DOCKETED	
Docket Number:	25-OPT-02
Project Title:	Prairie Song Reliability Project
TN #:	269328
Document Title:	Ruthie Brock Comments - Sensitive Receptor not identified— Acton Faith Bible School
Description:	N/A
Filer:	System
Organization:	Ruthie Brock
Submitter Role:	Public
Submission Date:	3/26/2026 9:49:02 AM
Docketed Date:	3/26/2026

Sensitive Receptor not identifiedâ€™ Acton Faith Bible School

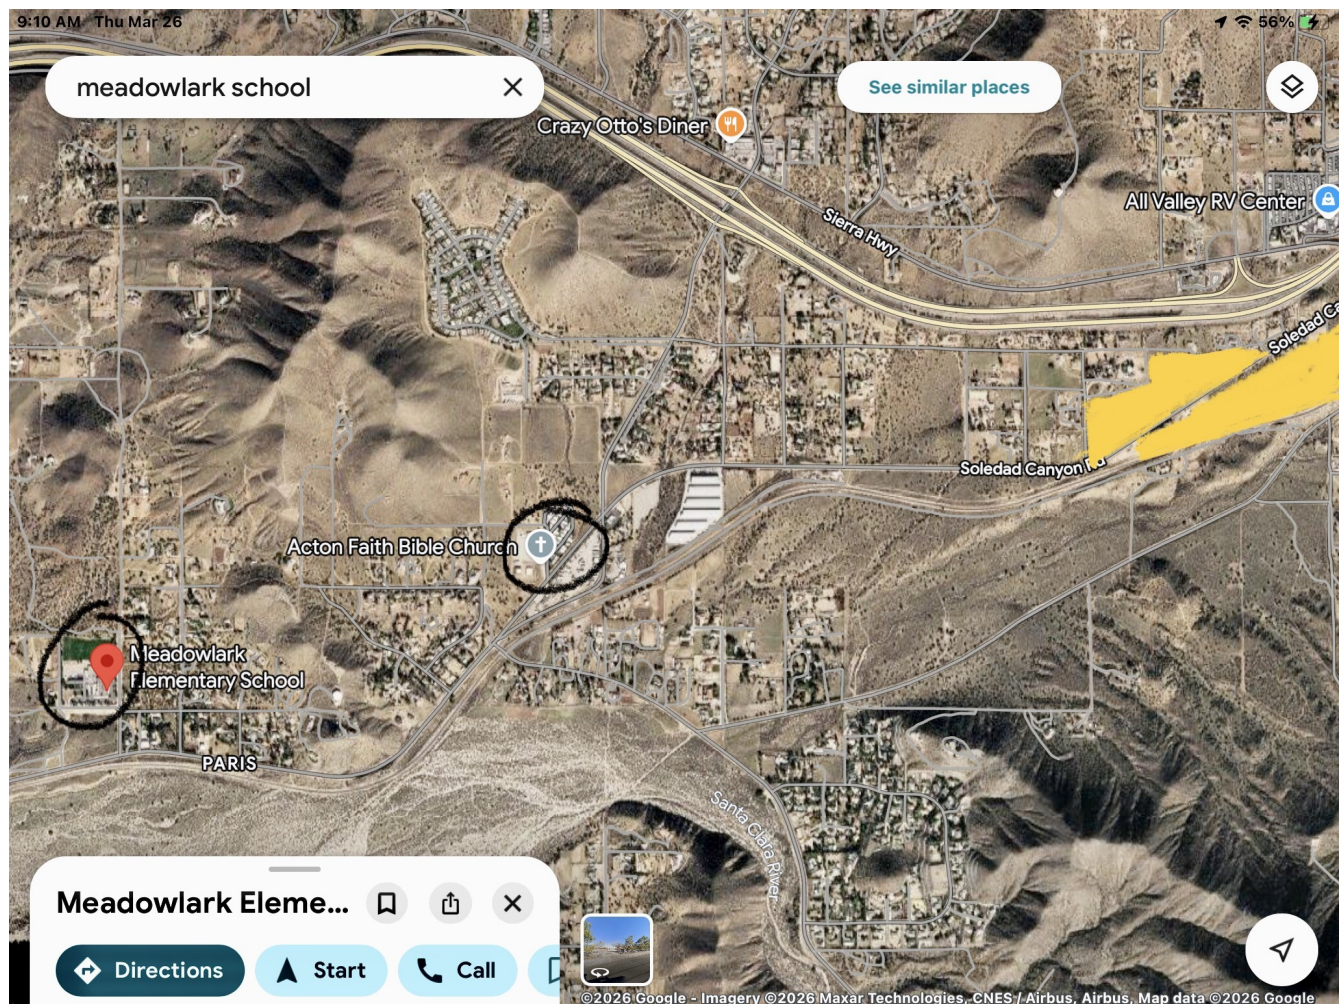
I wish to correct Dudek and Coval on the subject of sensitive receptors which were identified in Data Response #6 , Section 4 - Neighboring Uses (page 6). Dudek/Coval identified the nearest school as being Meadowlark Elementary which is 2 miles away from the PSRP. This is incorrect.

The map screenshot above shows both Meadowlark and the future Acton Faith Bible Church School location at 32643 Gem Way, Acton and their proximity to the Project.

Dudek and Coval continually fail to acknowledge this school which has been approved by LA County Regional Planning for development and has been identified in the Project docket.
